Re: Clean Machine Carwash
4200 San Mateo Blvd., NE
Traffic Circulation Layout
Engineer's/Architect's Stamp **6-9-16** (G18-D049)

DRAINAGE AND TRANSPORTATION INFORMATION SHEET

Re: Traffic Circulation Layout for 4200 San Mateo Blvd
87110

A1.1

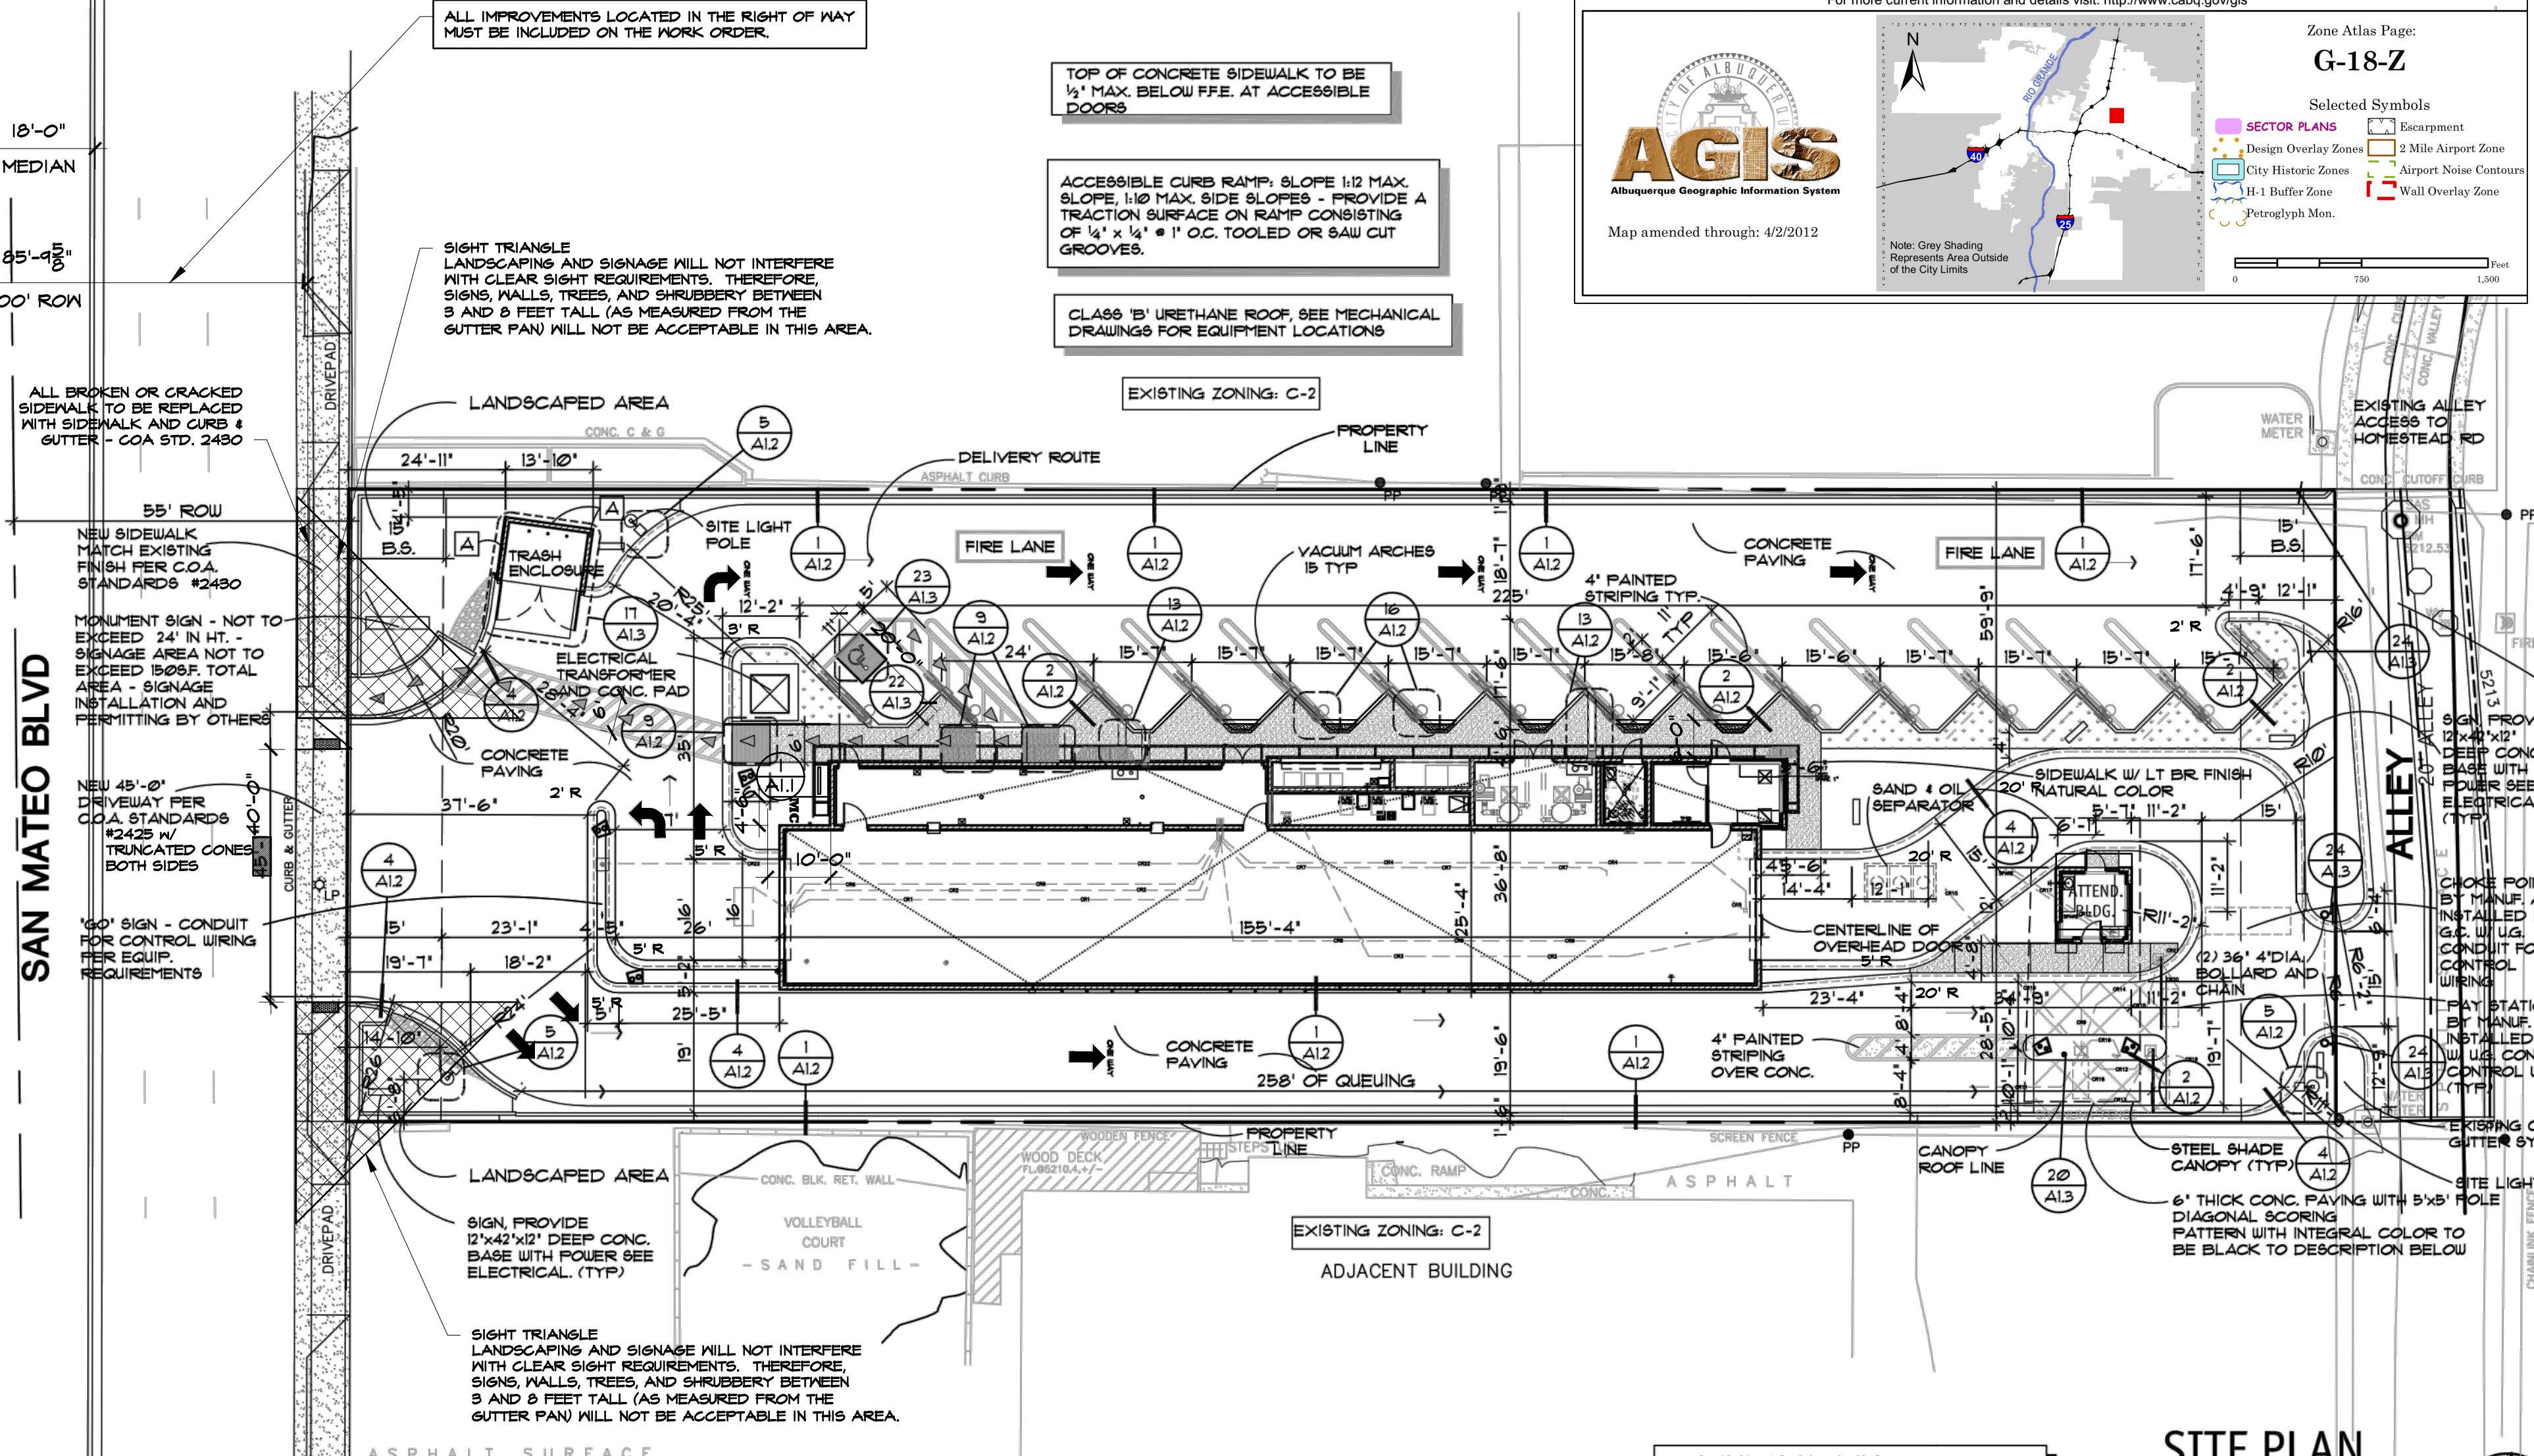
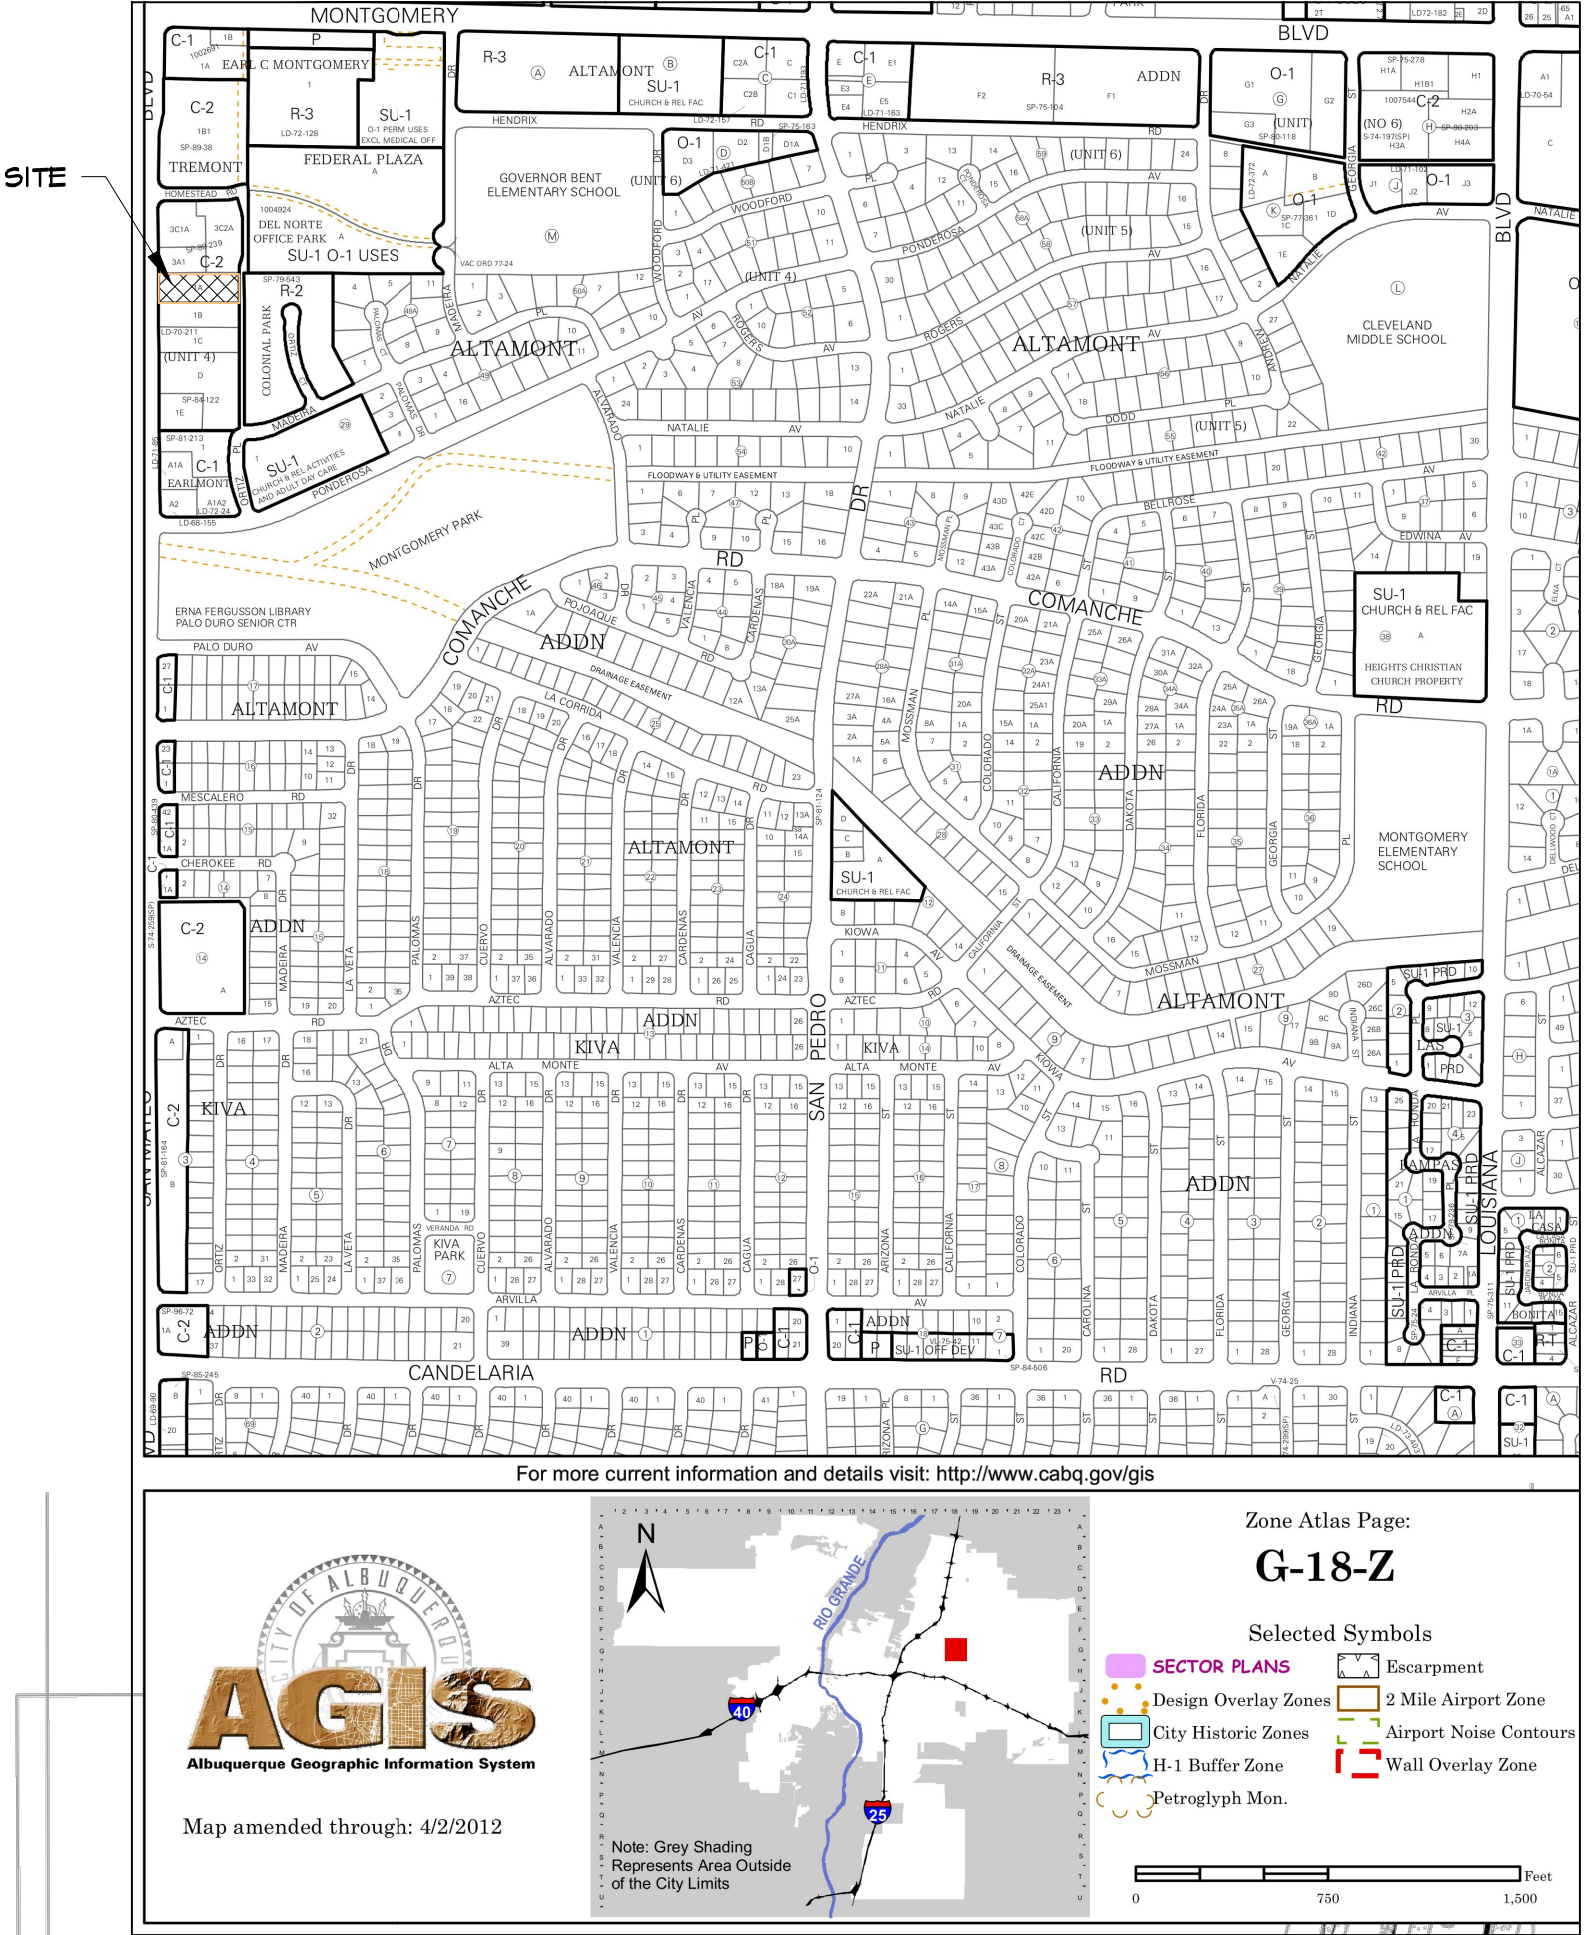
1. Clarify circulation of vehicles at the main entrance on San Mateo Blvd. There appears to be conflicting vehicle movements. Please add detail of directional arrows and signage.
2. Detail and dimension bicycle and motorcycle parking spaces, along with appropriate signage.
3. The ADA accessible parking sign must have the required language per 66-7-352.4C NMSA 1978 **"Violators Are Subject to a Fine and/or Towing."** Please call out detail and location of HC signs. See attached 2009 NM Accessible Parking Checklist page 3 of 6.
4. One-way vehicular paths require pavement directional signage and a posted **"Do Not Enter"** sign at the point of egress. Please show detail and location of posted signs.
5. Please specify the City Standard Drawing Number when applicable.
6. Please include two copies of the traffic circulation layout at the next submittal.

1. See details on Sheets A1.2 & A1.3
2. Arrows shown on Sheet A1.1
3. Curb is shown as 40' on A1.1
4. See dimension on Sheet A1.1
5. Median and ROW shown on A1.1
6. Added MC and bike rack to A1.1
7. Dimension of handicap accessible space on A1.1
8. ADA sign shown on detail 22/A1.3
9. See A1.1 for 6 ft wide ADA access
10. Curb details shown on 1&4/A1.2
11. Do Not Enter signs shown on A1.1 as Detail 24/A1.3
12. City standards called out on A1.1
13. Added note to A1.1
